CITY PLAN COMMISSION

FILE NUMBER: Z212-271(JA)-R **DATE FILED:** May 25, 2022
LOCATION: Northeast corner of Linfield Road and Bonnie View Road
COUNCIL DISTRICT: 4
SIZE OF REQUEST: Approx. 10.19 acres **CENSUS TRACT:** 48113008703

REQUEST: An application for a Specific Use Permit for a public school other than an open-enrollment charter school on property zoned an R-5(A) Single Family District.

SUMMARY: The purpose of the request is to allow for the construction of a new public school to replace the existing public school. [W.W. Bushman Elementary School]

PROPOSED TRAFFIC MANAGEMENT PLAN *[Initial Proposal; See revised.]*

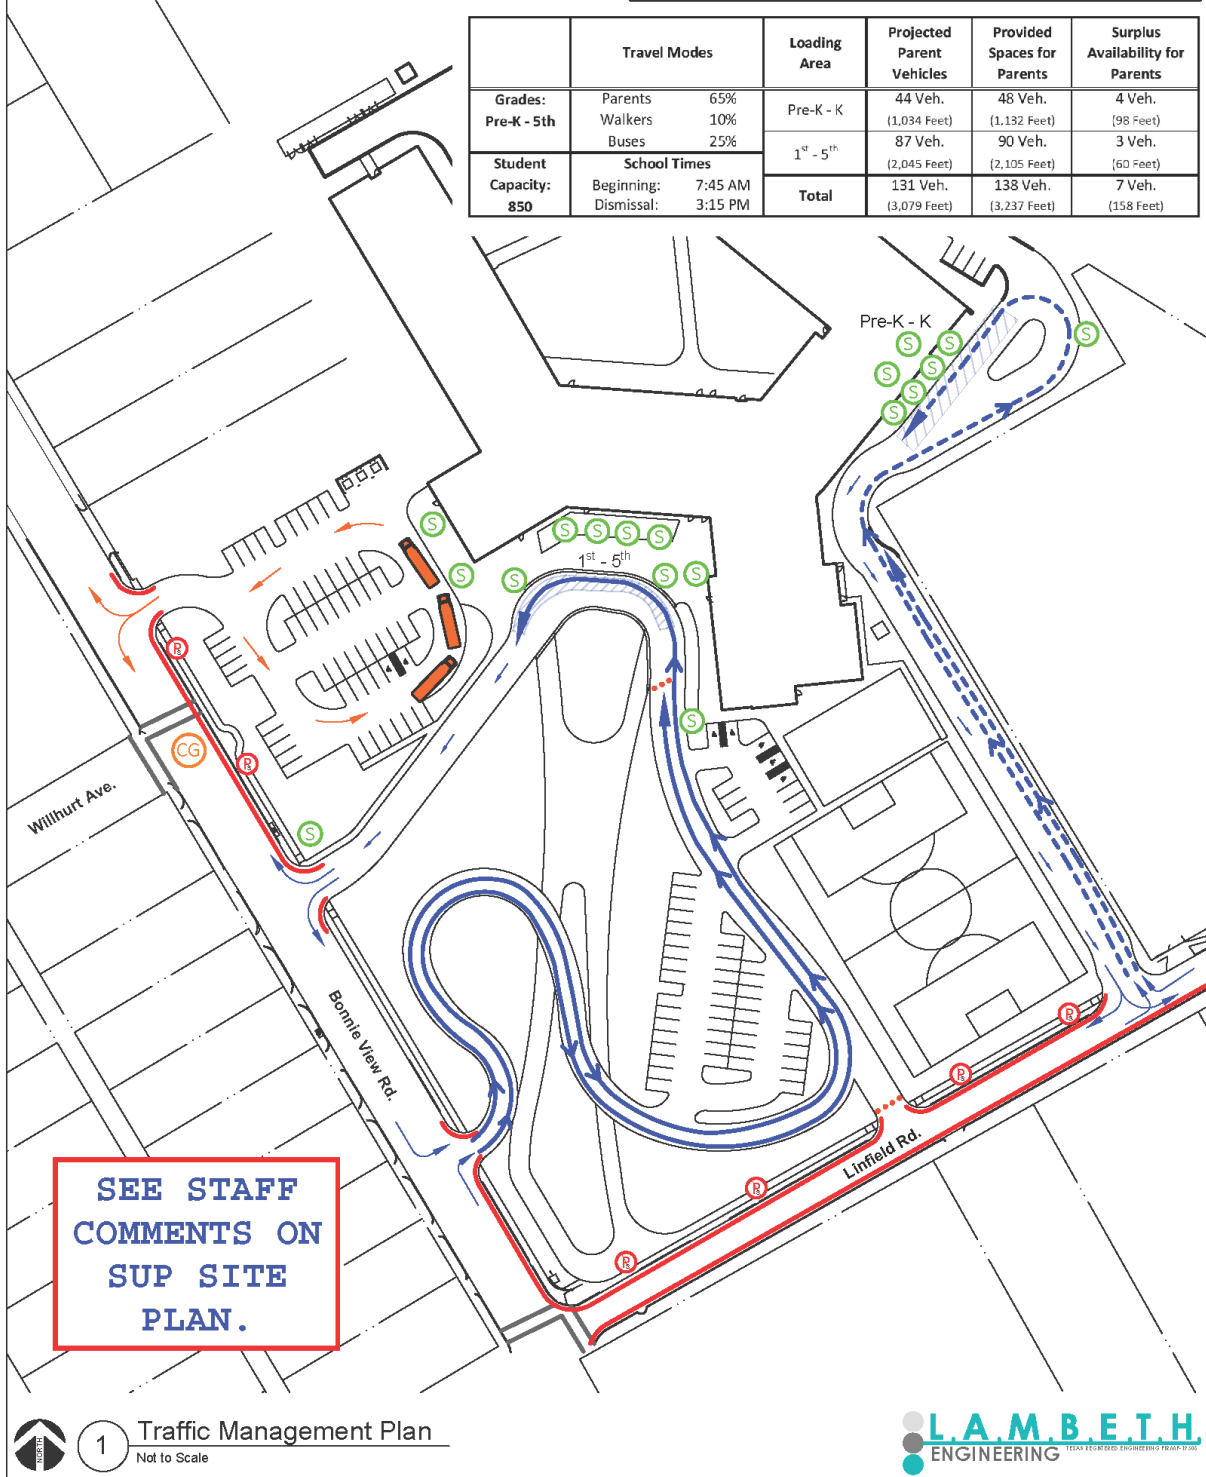
**SEE STAFF
COMMENTS ON
SUP SITE
PLAN.**

**SEE STAFF
COMMENTS ON
SUP SITE
PLAN.**

SEE STAFF
COMMENTS ON
SUP SITE PLAN.

**SEE STAFF
COMMENTS ON
SUP SITE
PLAN.**

PROPOSED TMP [Revised; Further Revisions Pending.]

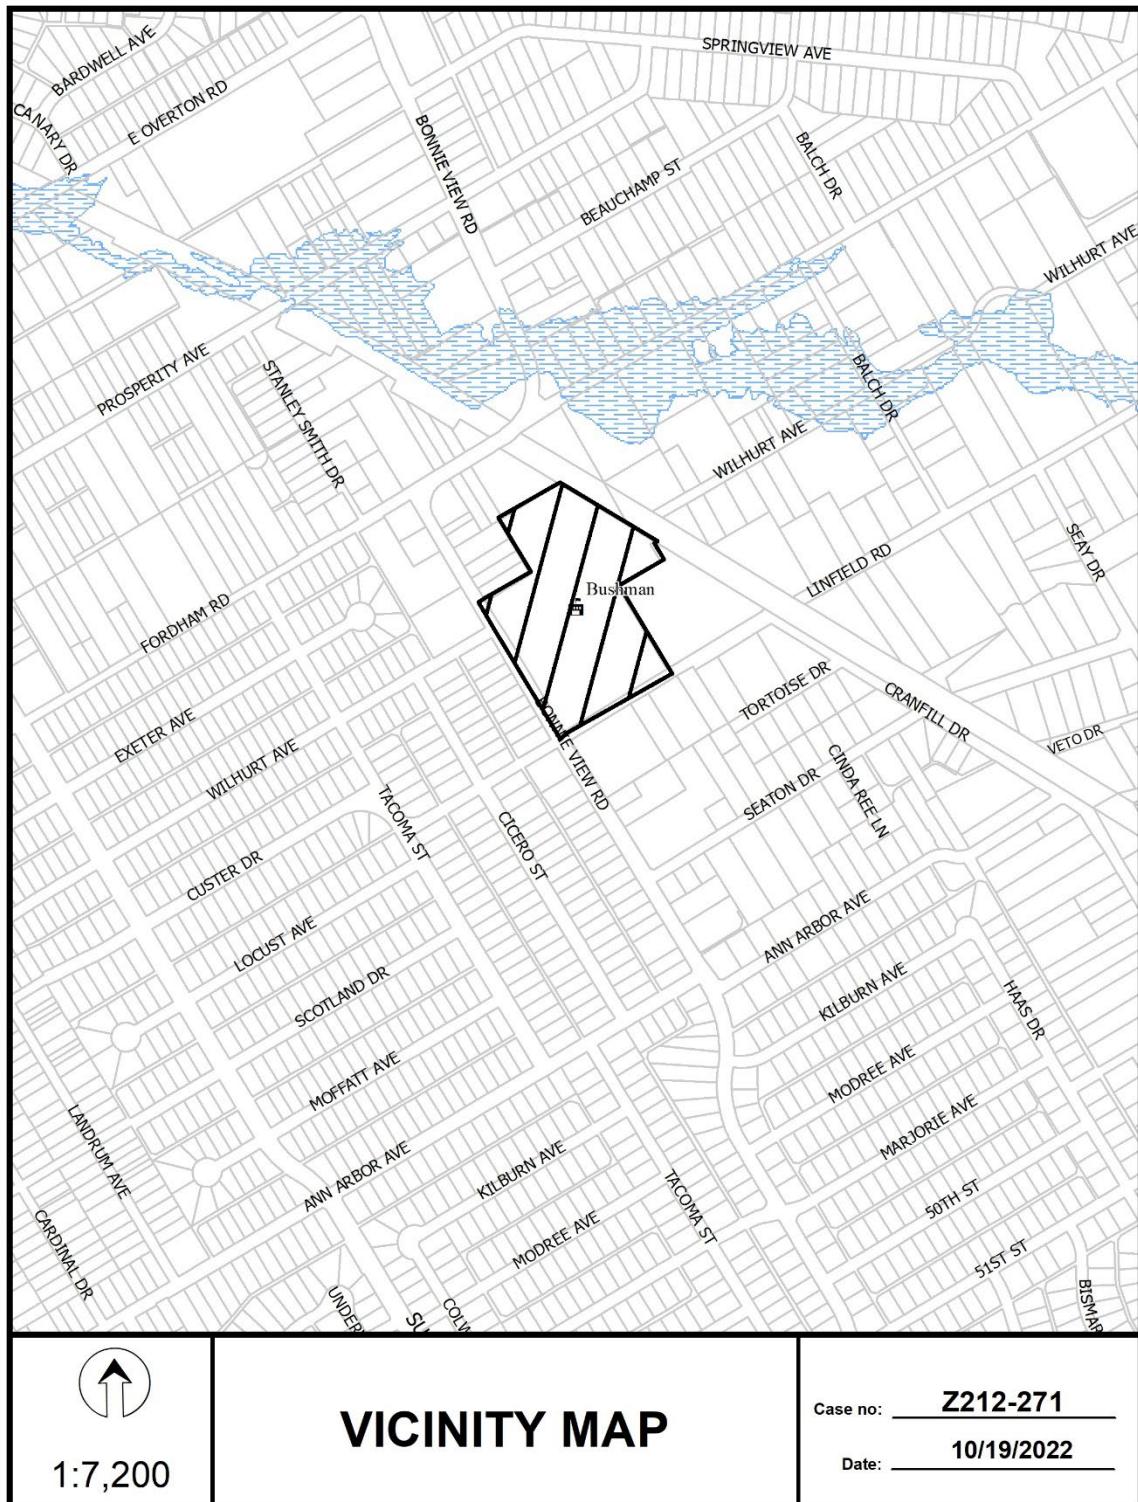
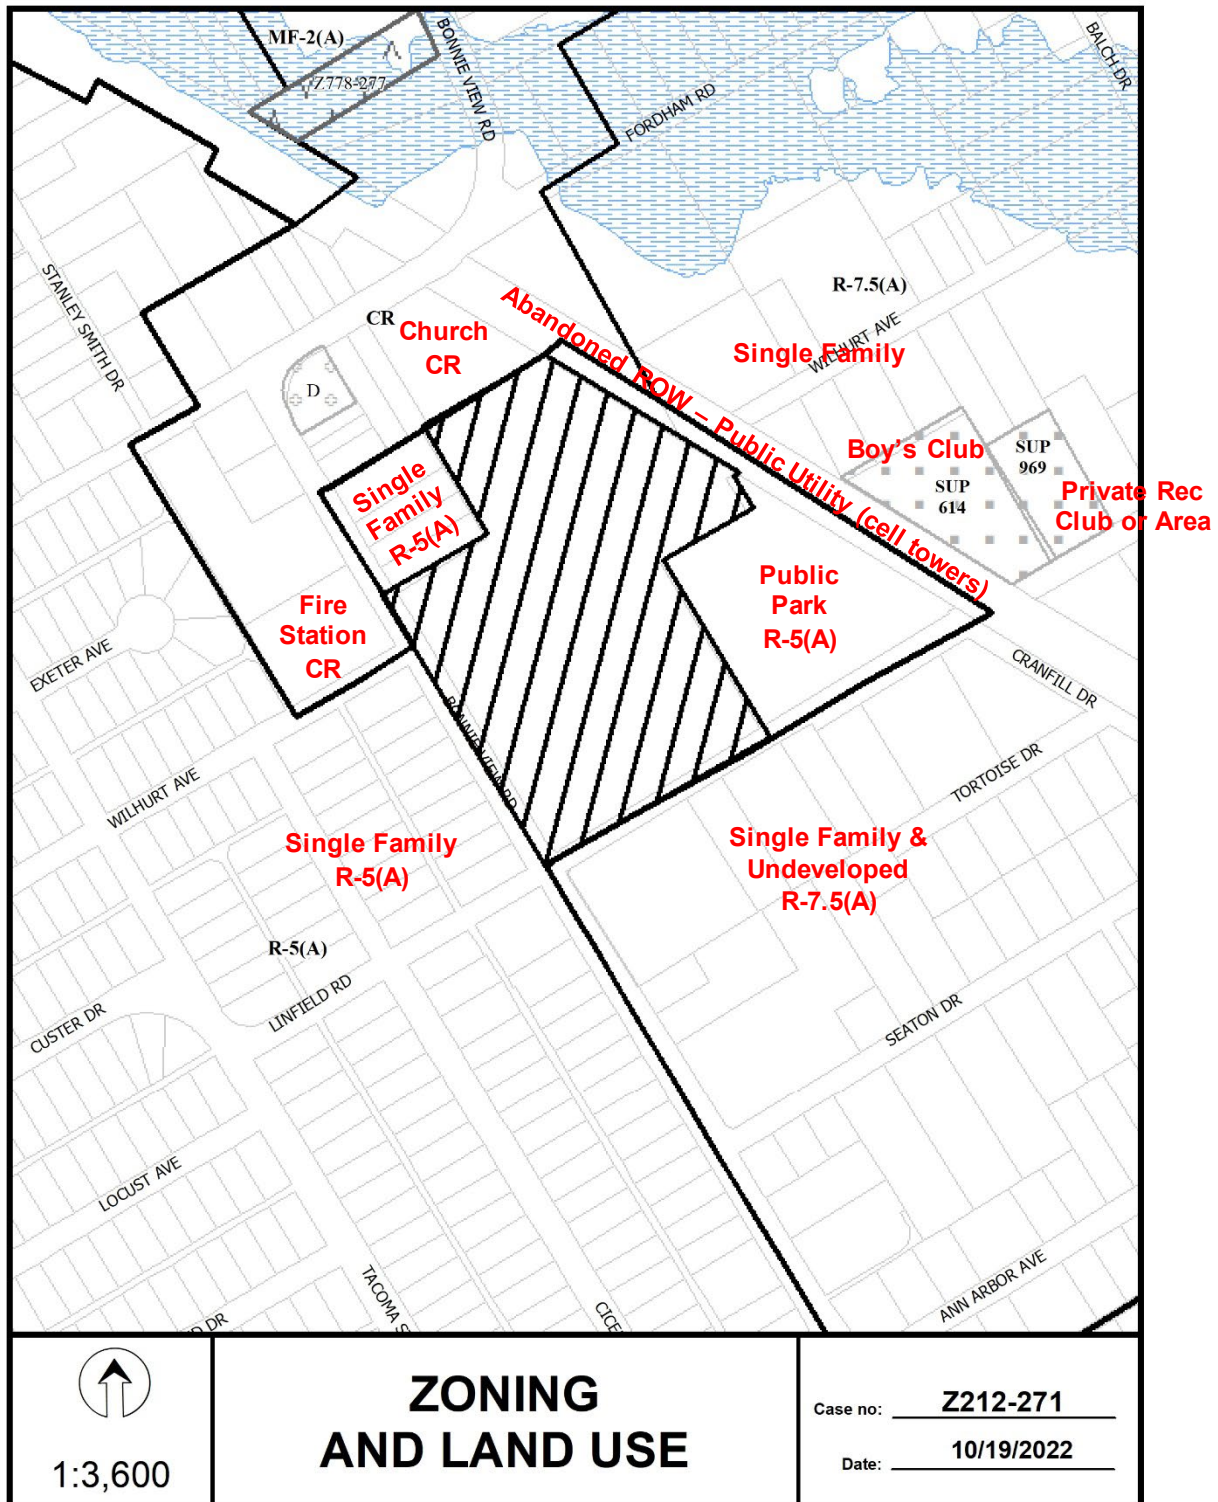
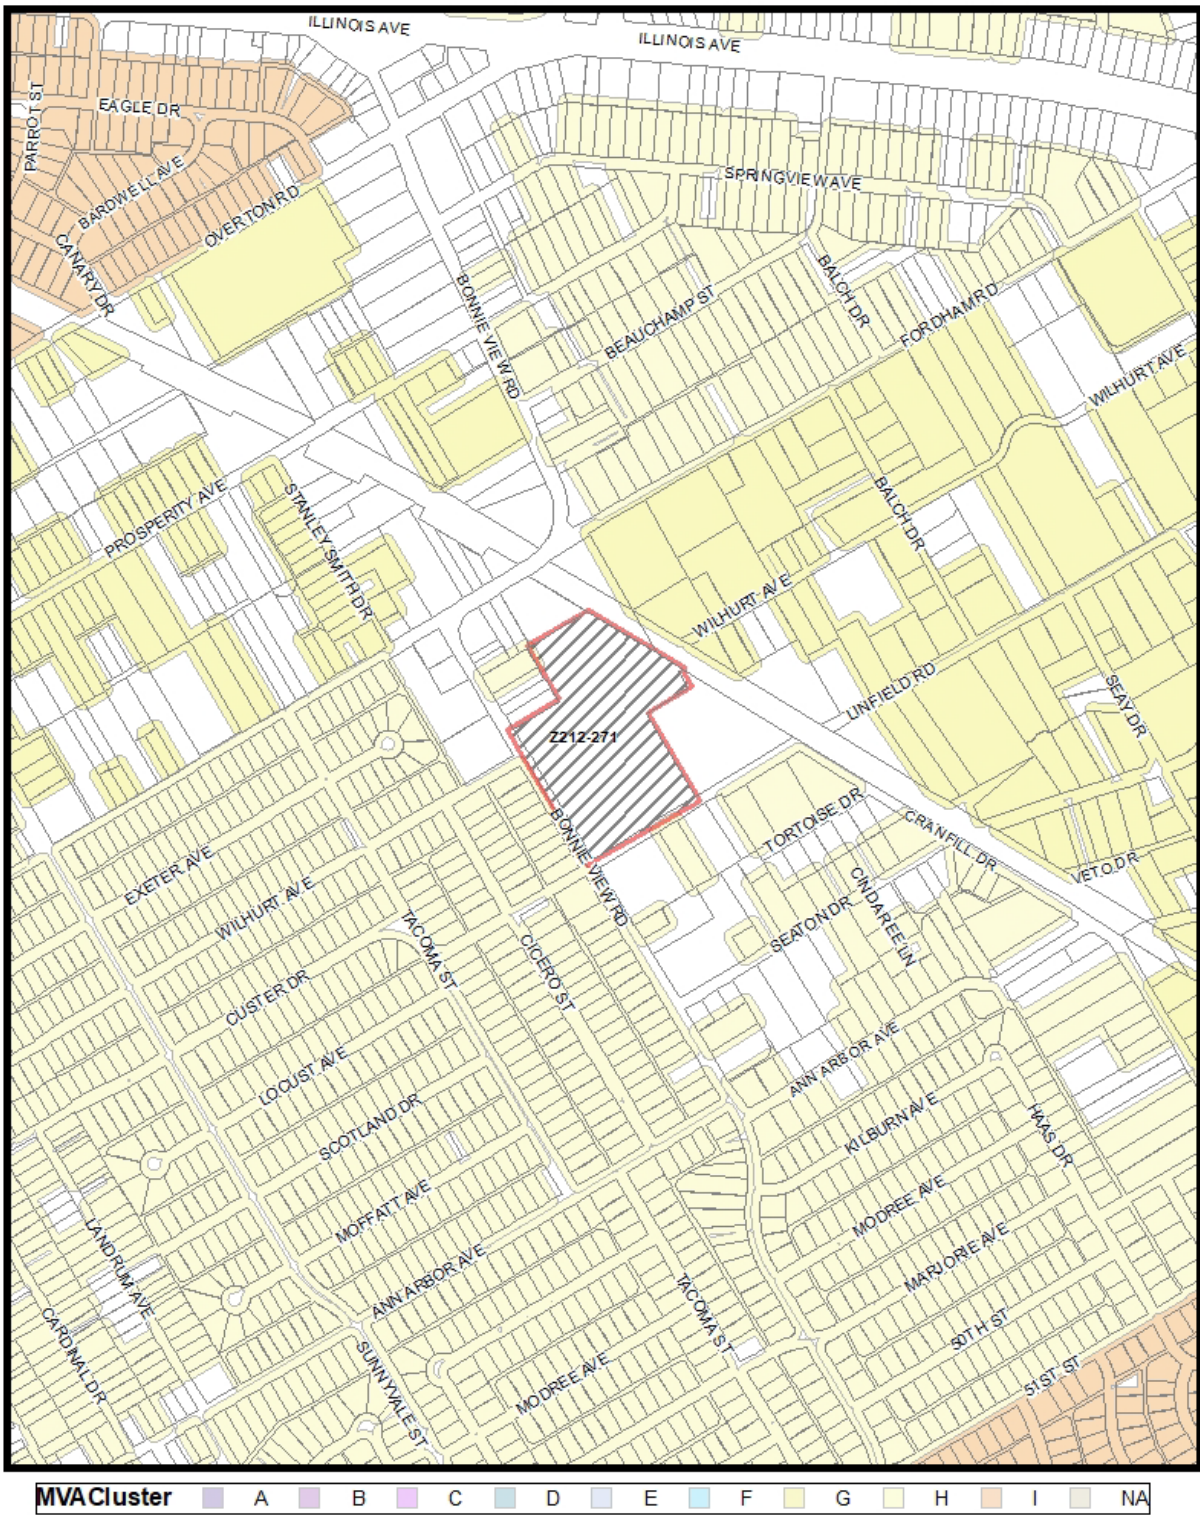
The Transportation Development Services Division of the Transportation Department has reviewed the current zoning request and recommends the following modifications to the site plan and the TMP:

- Revise internal connection with perpendicular intersection.
- Add paved pedestrian path along circuitous driveways and/or pedestrian routes through the campus from all access points.
- Extend throat of driveway on Linfield to avoid abrupt turn since design does not physically discourage wrong way turns.
- Minimum 5'-0" wide sidewalk is required for ADA compliance; however, staff recommends minimum 6'-0" wide sidewalks at schools. The Street Design Manual indicates a minimum 5'-0" wide buffer is required between back of curb and leading edge of sidewalk.

Staff finds that the revised TMP proposal better supports pedestrian access to/from the site and circulation within the site to building entries; however, it is recommended that access routes be designed in a manner that will allow pedestrians to access building entries without the need to cross internal vehicular traffic/queue lines. Where pedestrian pathways do intersect with queue lines, staff recommends that these intersections occur at 90 degrees. Further, staff has requested that the applicant explore the possibility of removing the southernmost ingress-only point on Bonnie View Road and reconfiguring the circuitous route to provide a combined ingress/egress point along Bonnie View Road.
